## **City of Ryde Submission**

**4-38 Talavera Road Macquarie Park- SSD-46011220  
Multi-level Warehousing Complex**

**COR2022/95**

**Submission Date: 14 March 2023**

**STORMWATER DRAINAGE PLAN**  
**LOWER CARPARK**  
SCALE 1:400

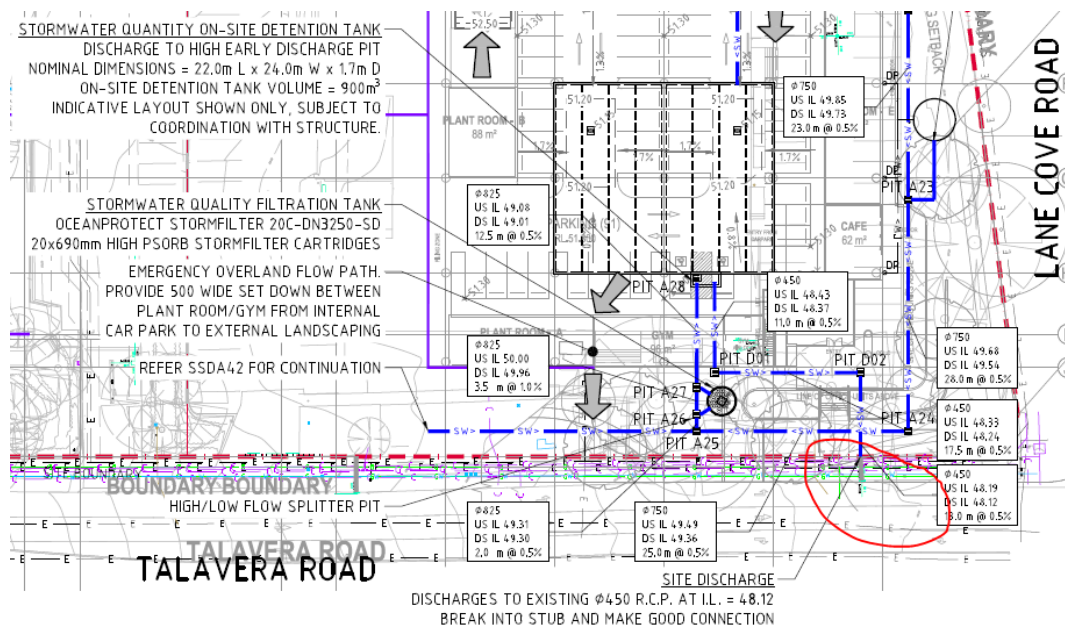
Civil Engineering Plan prepared by Costin Roe Consulting (Revision C) dated 17 August 2022 shall be amended to reflect the following:

- The stormwater from the site must be connected to new pit or use available Council pit adjacent to the site at Talavera Road. The stormwater connection detail to Council pit shall be included in the SWMP.
